ADDENDUM NO. 03
December 19, 2025

To Drawings and Specifications dated December 05, 2025.

PKG 3B – GPHS ATHLETICS, ACADEMIC & MULTI-PURPOSE FACILITY

Prepared by: PBK
11 Greenway Plaza, 22nd Floor
Houston, TX 77046-1104
PBK Project No: 240539

C 201

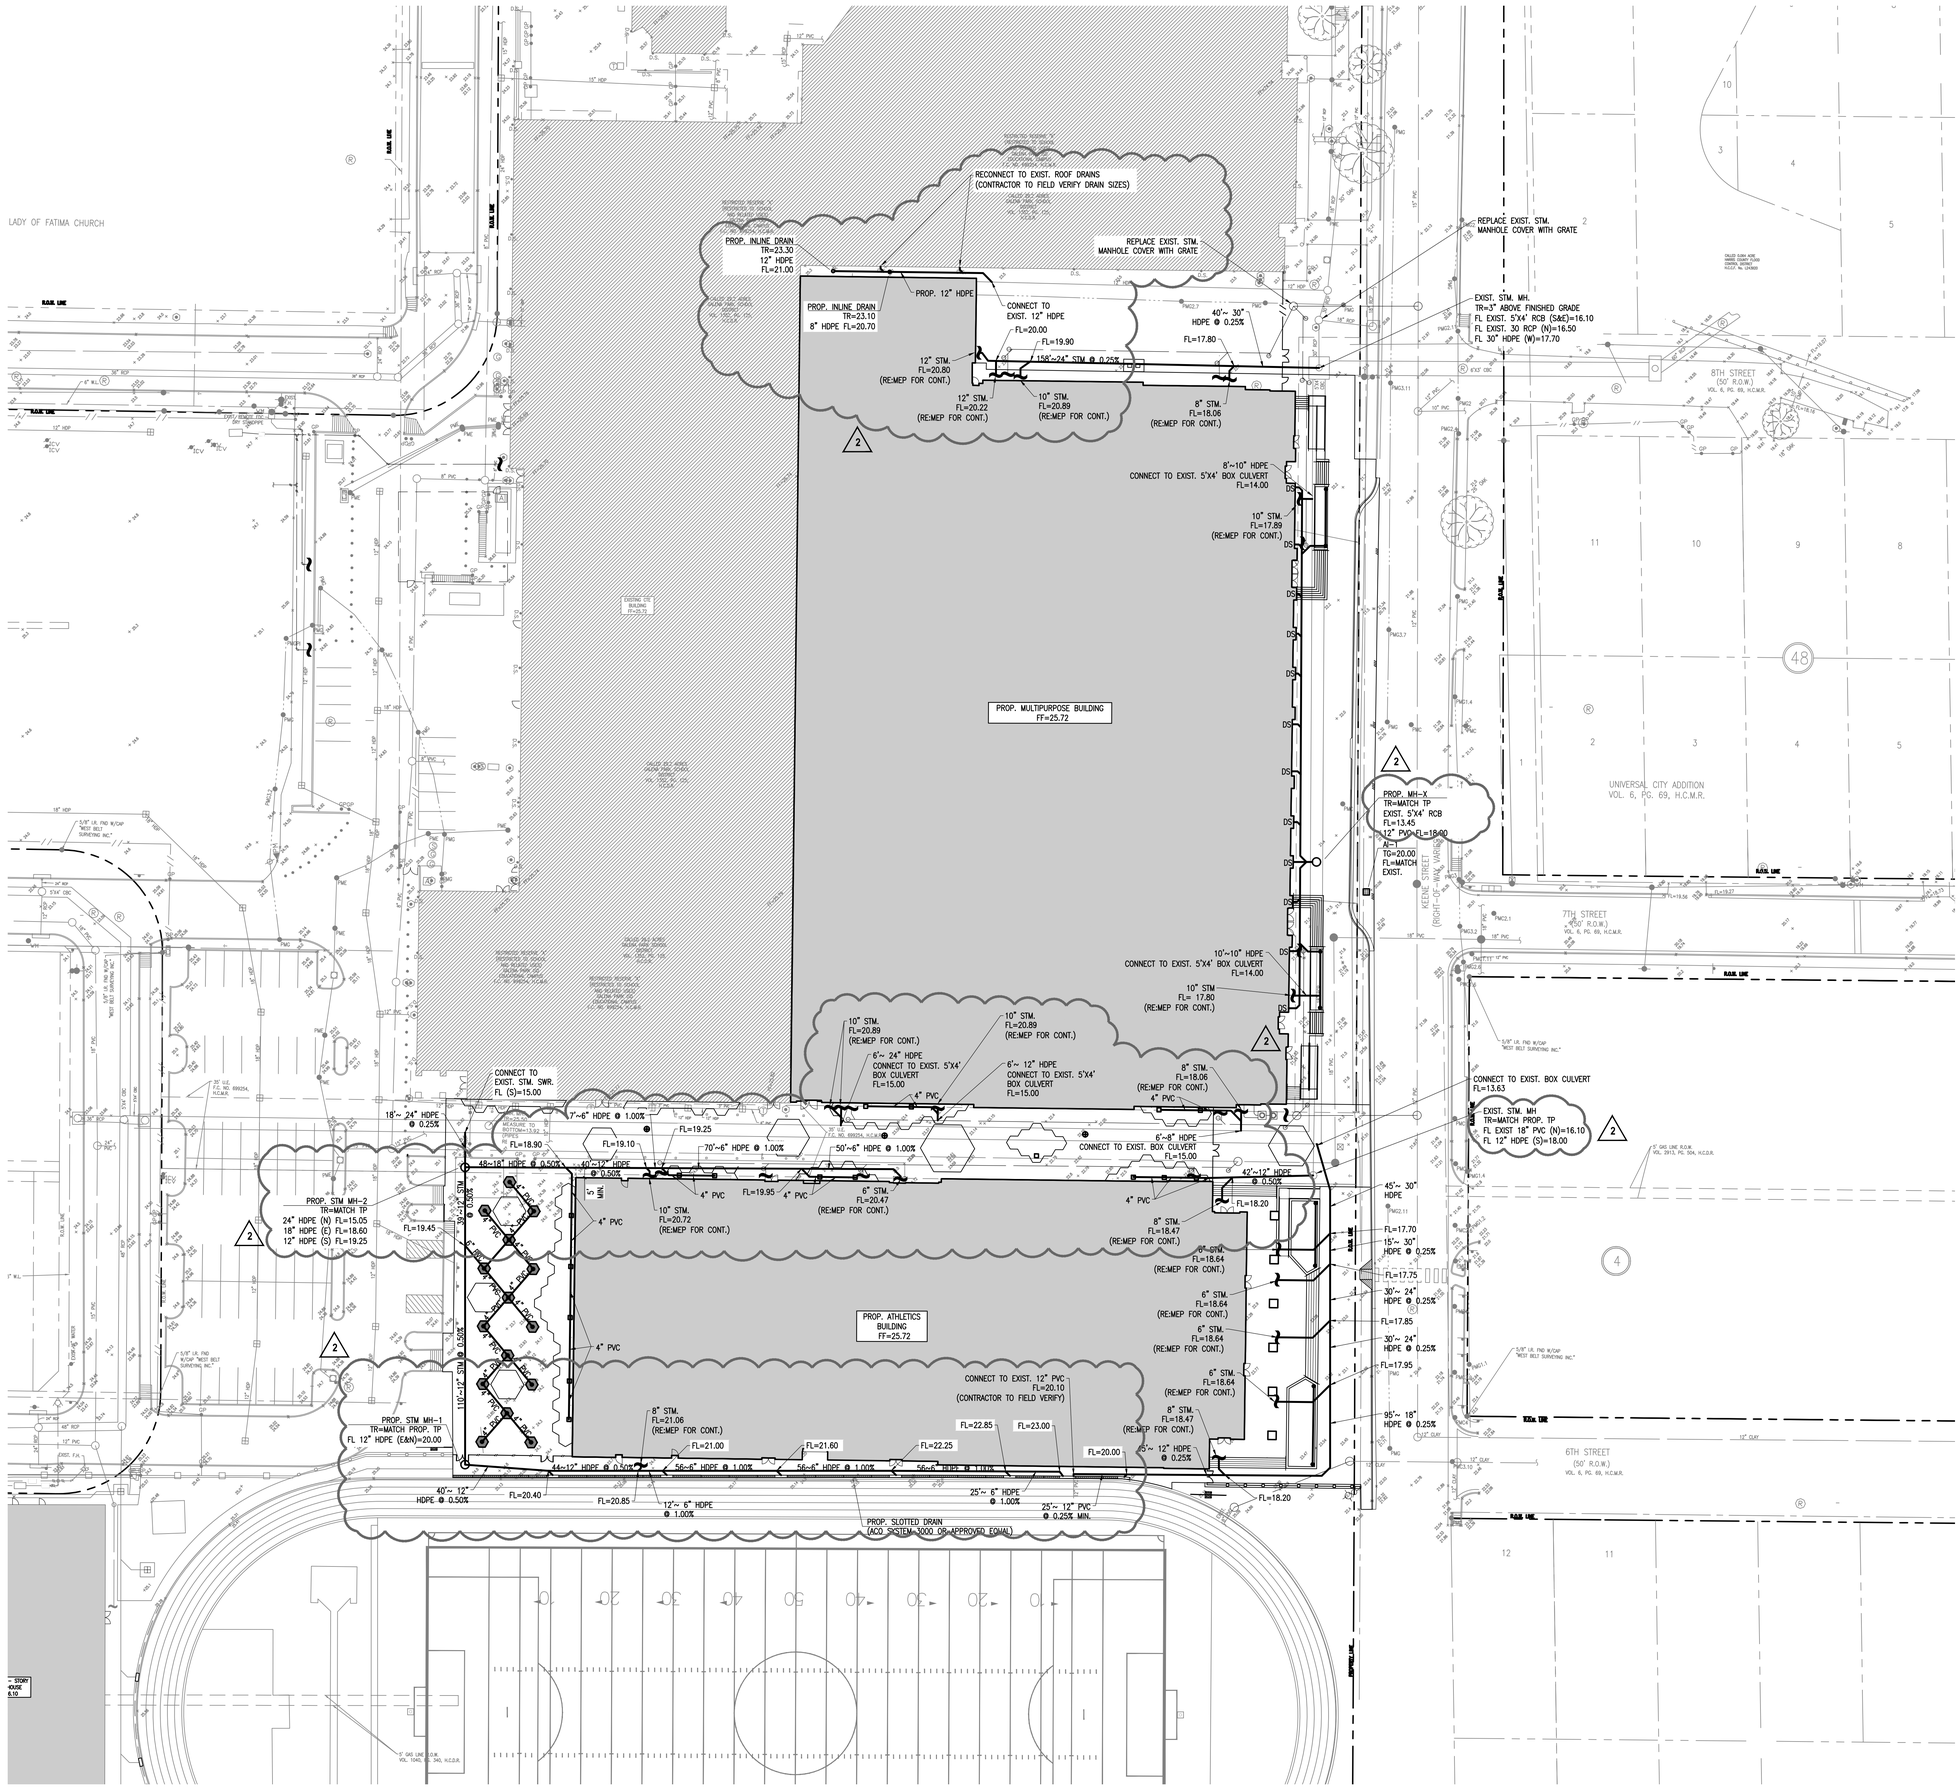
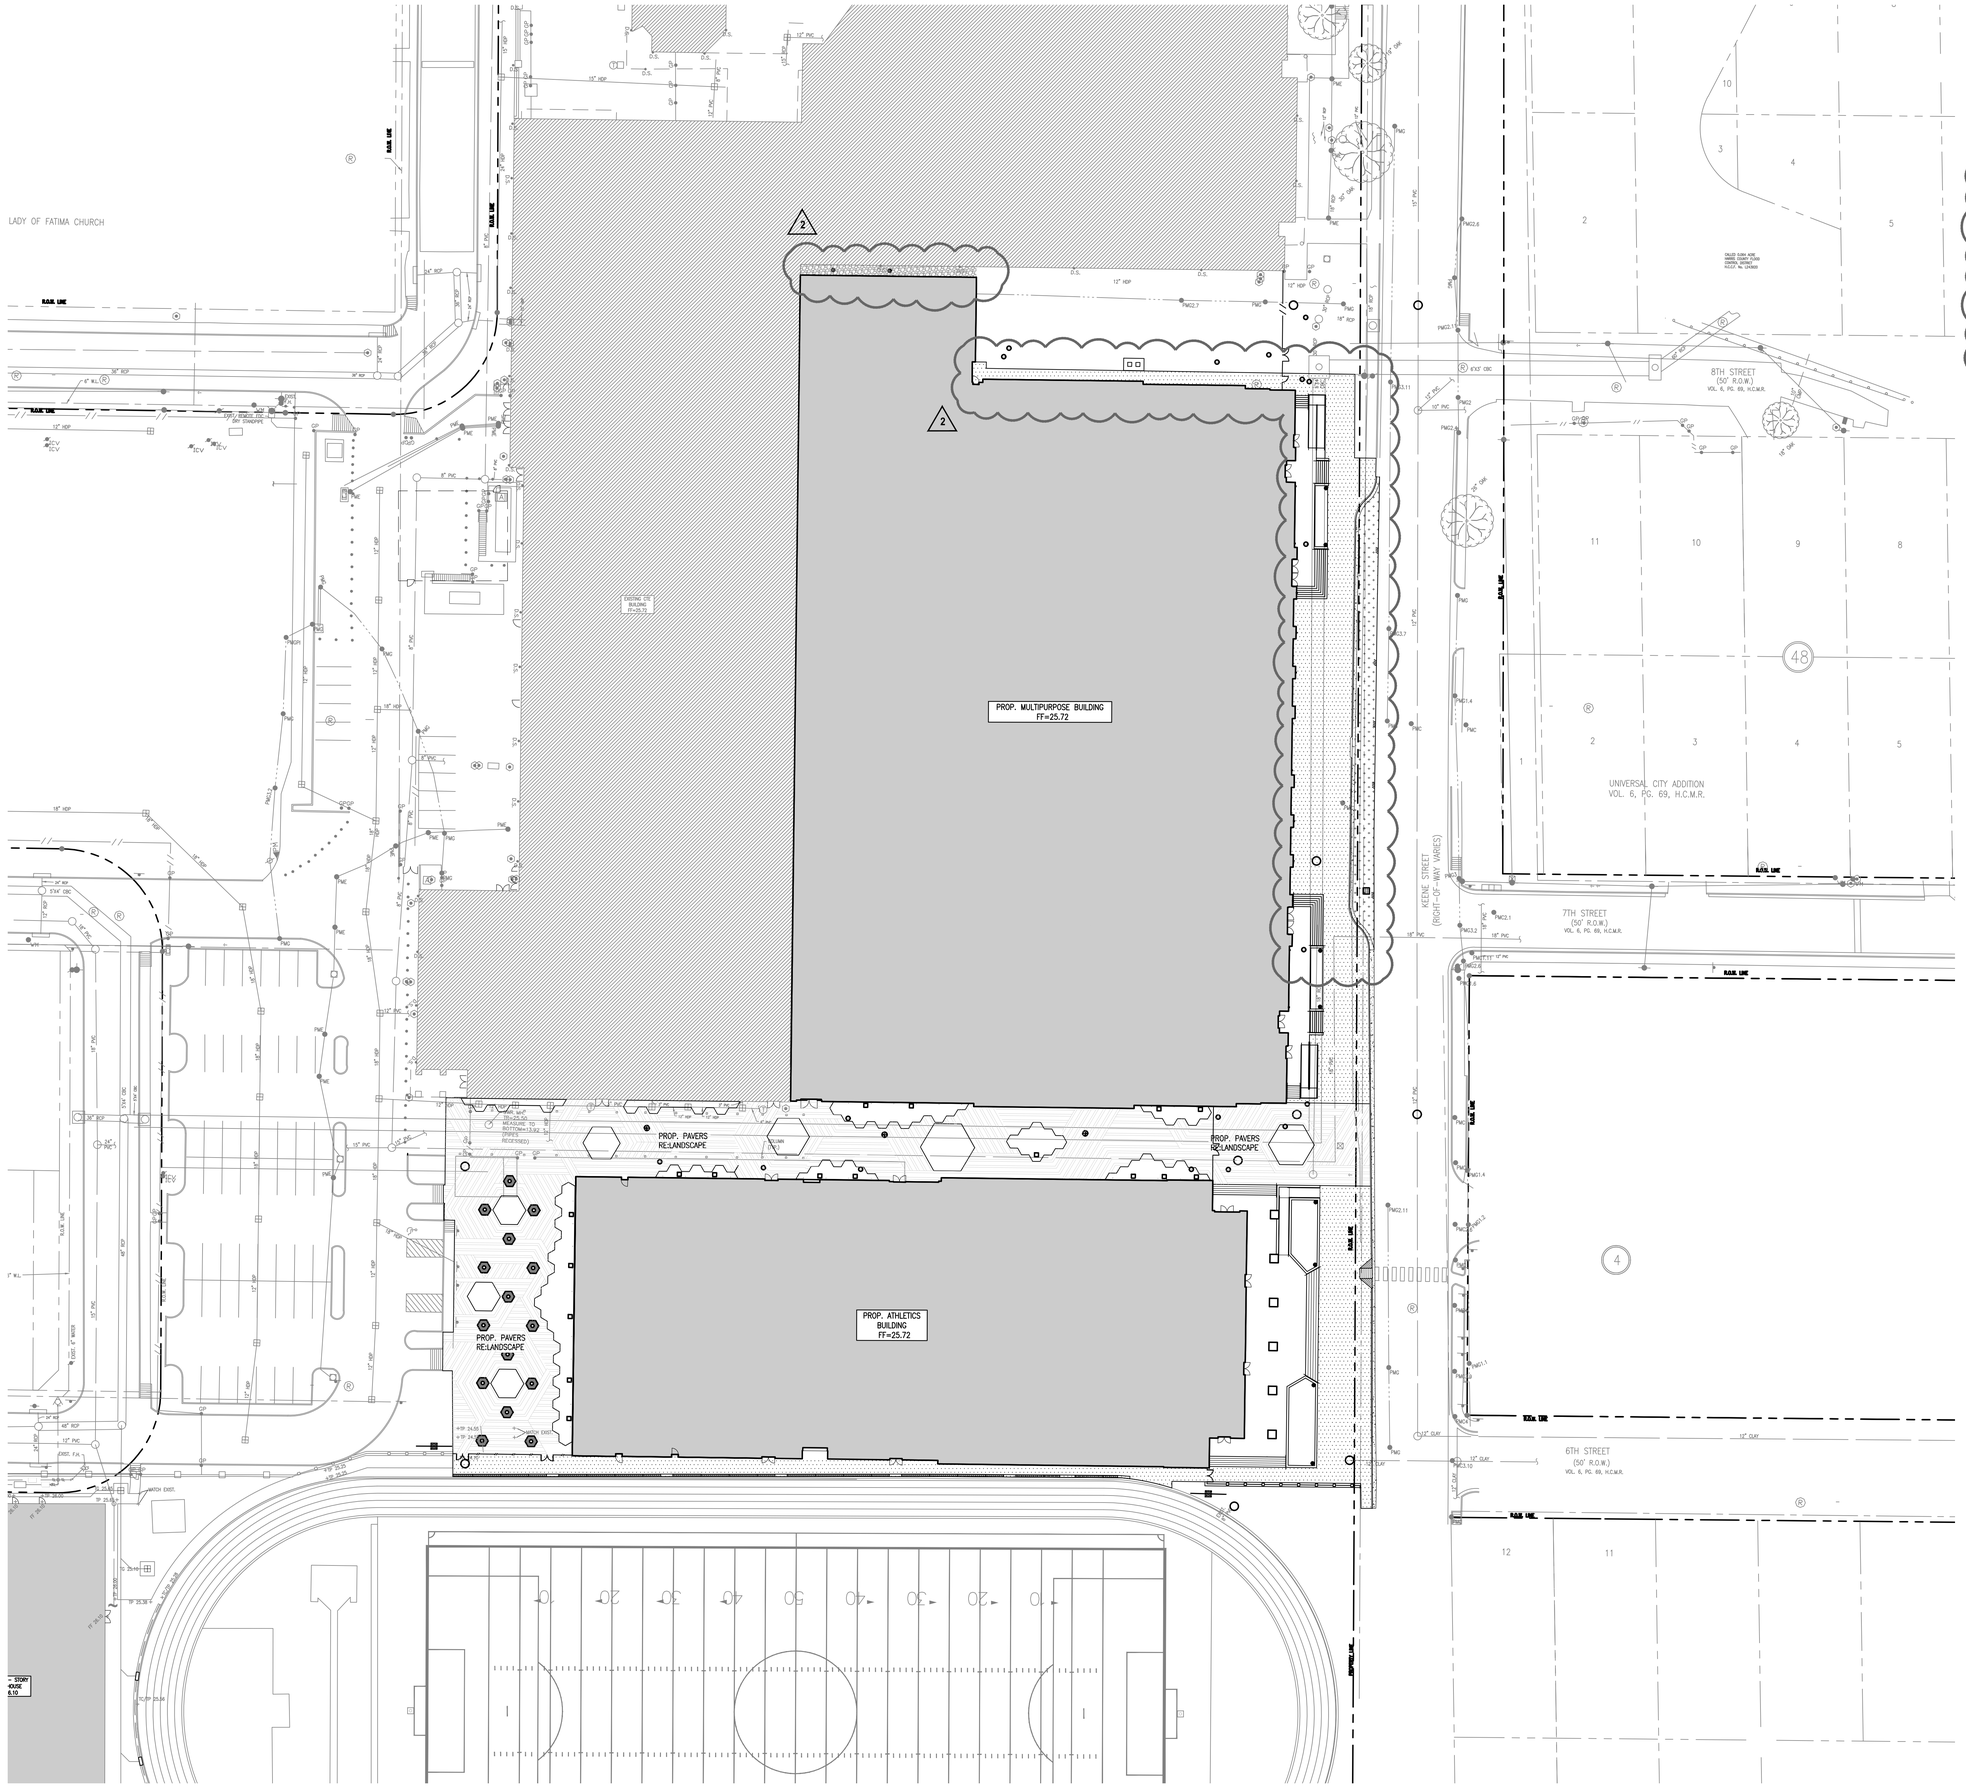
Question 39: 2/L4.03 shows an area of sod with trees along Keene Street while C402 shows sidewalk covering this entire area. Please clarify.

i. Follow Landscape drawing - 2/L4.03.

LEVEL 1 - AREA A FLOOR PLAN
A-101A
FOR BLUEBEAM LABELING/DOOR:

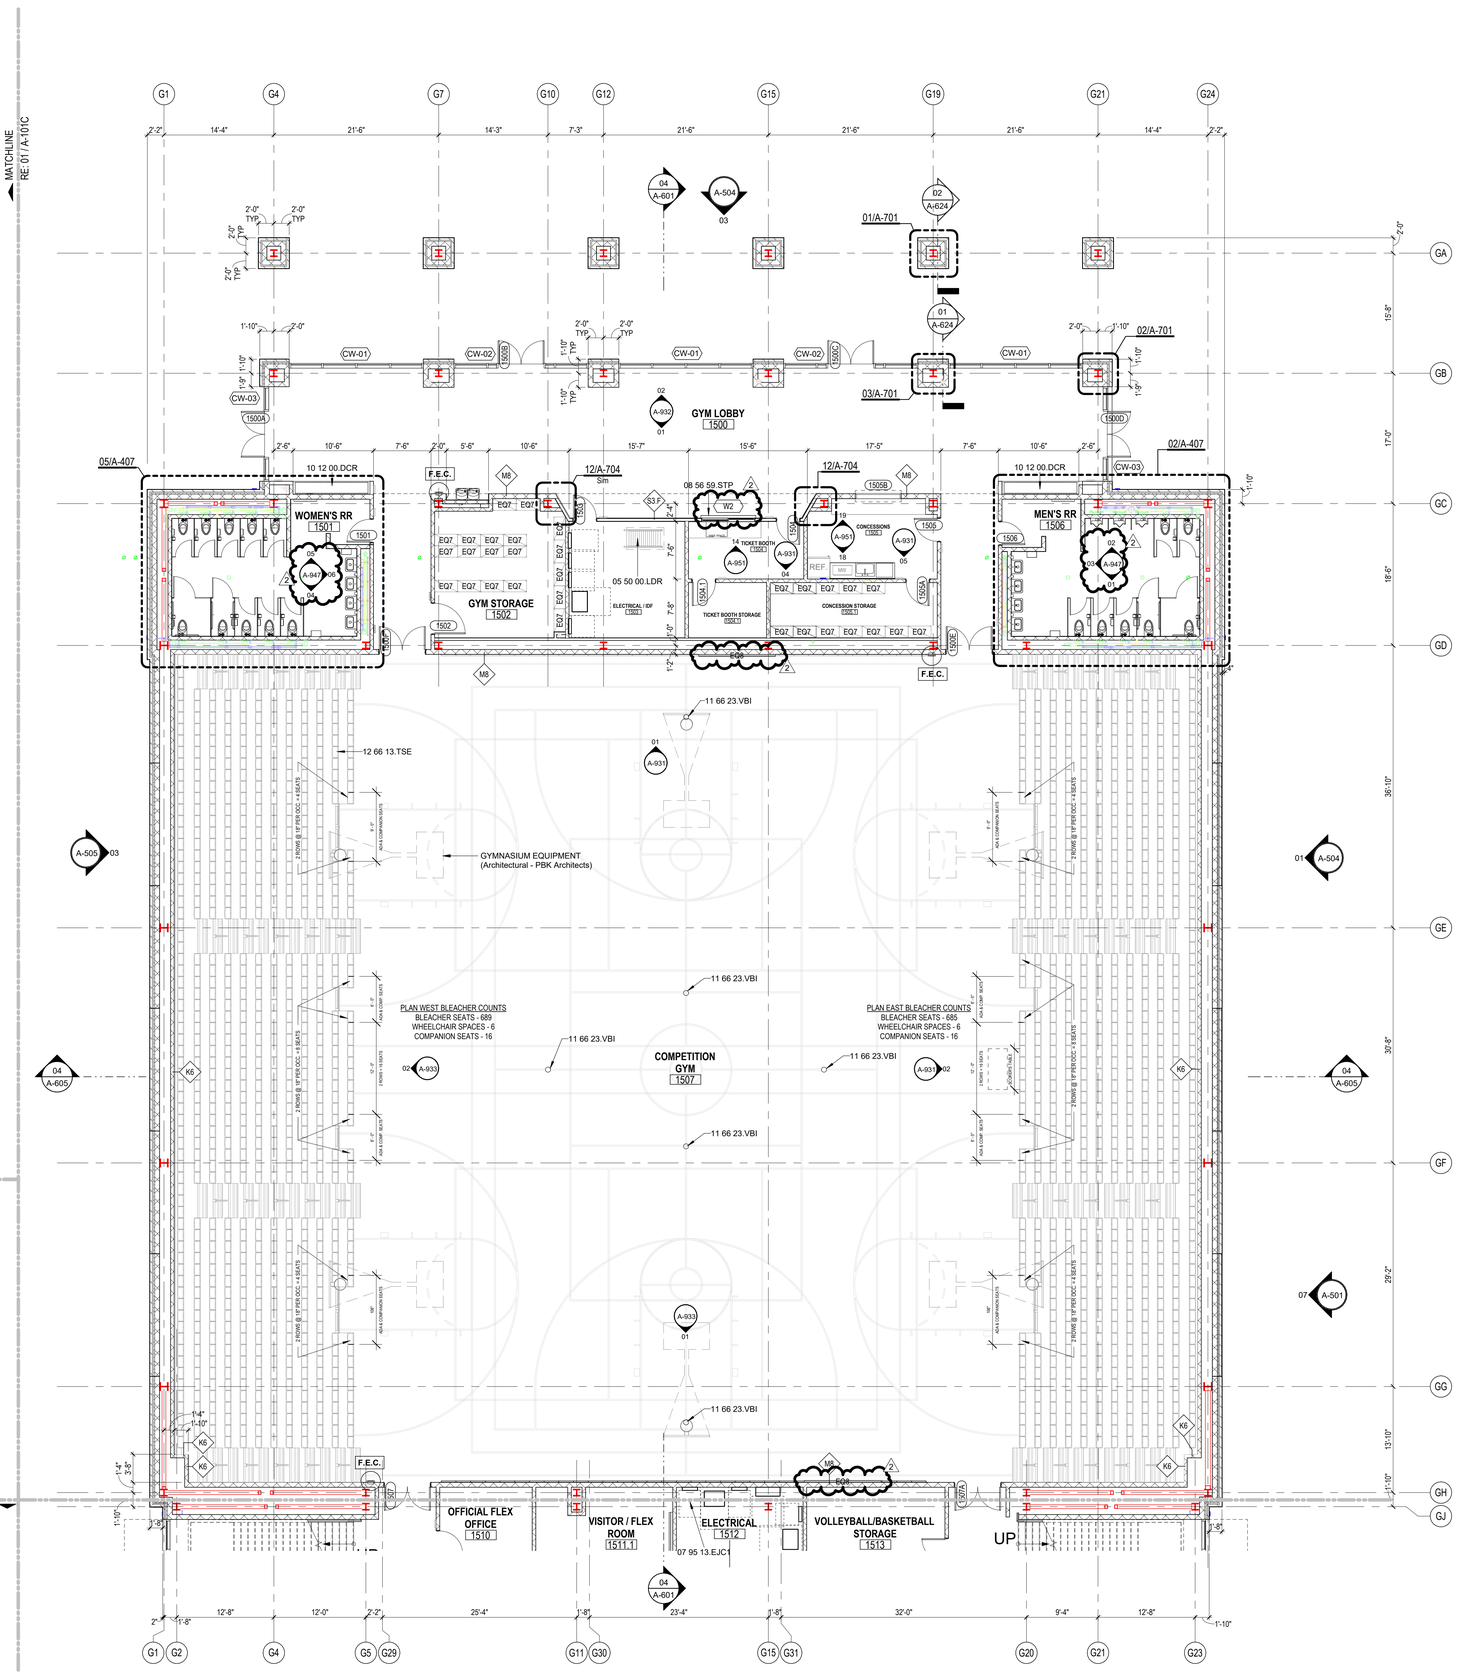
Question 02: Sheets A101A & B show several rooms with shelving units marked EQ9. The Equipment Schedule indicates 50 EQ4 wire shelving units, and 91 EQ7 wire shelving units from Uline are required. Only 79 EQ7 shelving units are shown. Please address discrepancy in the count. Specification 10 56 13 has 7 manufacturers listed as acceptable. Uline called out in the Equipment Schedule is not one of them. Please clarify which type of shelving is required.

i. Response: Equipment scheduled has been updated per sheet. A-101A only includes EQ7 with a count of 31. A-101B equipment schedule "count" updated.
